Access Compliance Report

Public Rights-of-Way

Intersection ID: 3352	Main Street: DAVIS_RIDGE_DR	Cross Street: FALLS_RIDGE_LN	Location: SW
ADA ID: DC4AD2E98E9B	Ramp Type: PerpDiag	Initial Pass/Fail: Fail	Overall Compliance: No
Severity Score: 33.75			
Codes/Mitigation Info/Possible Solution		Field Measurements/Component Compliance

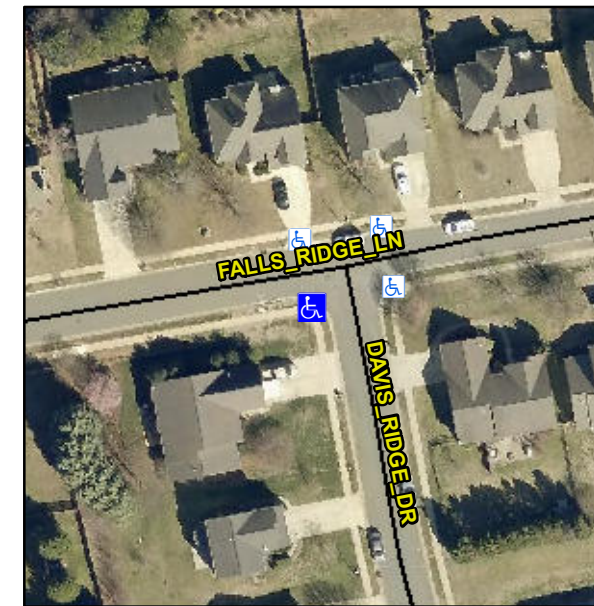
R304.5.1, R304.5.3

Compliance	Description	Data	Compliance	Description	Data
N/A	Ramp Length (in)	48.0	Yes	Ramp Slope (%)	5.6
No	Ramp Width (in)	47.0	No	Ramp XSlope (%)	11.9
N/A	Flare Type LT	N/A	N/A	Flare Type RT	N/A
N/A	Flare Slope LT (%)	N/A	N/A	Flare Slope RT (%)	N/A
N/A	Flare Traversable LT?	N/A	N/A	Flare Traversable RT?	N/A
N/A	Landing Length (in)	N/A	N/A	DWS Provided?	N/A
N/A	Landing Width (in)	N/A	N/A	DWS Contrast?	N/A
N/A	Landing Slope (%)	N/A	N/A	DWS Length (in)	N/A
N/A	Landing X Slope (%)	N/A	N/A	DWS Full Width?	N/A
N/A	Landing Curb? (Y/N)	N/A	N/A	DWS Offset (in)	N/A
N/A	Shared Landing?	N/A			
N/A	Gutter Ponding?	N/A	N/A	Gutter Slope (%)	N/A
N/A	Gutter Lip Ht (in)	N/A	N/A	Gutter X Slope (%)	N/A
N/A	Painted X Walk1?	No	N/A	Painted X Walk2?	No
	X Walk 1 Direction	To E		X Walk 2 Direction	To N
N/A	X Walk 1 Width (in)	N/A	N/A	X Walk 2 Width (in)	N/A
	X Walk 1 Slope (%)	4.1		X Walk 2 Slope (%)	5.5
	X Walk 1 X Slope (%)	10.6		X Walk 2 X Slope (%)	6.8

Remove & Replace Curb Ramp With Two New Directional Ramps or Equivalent.
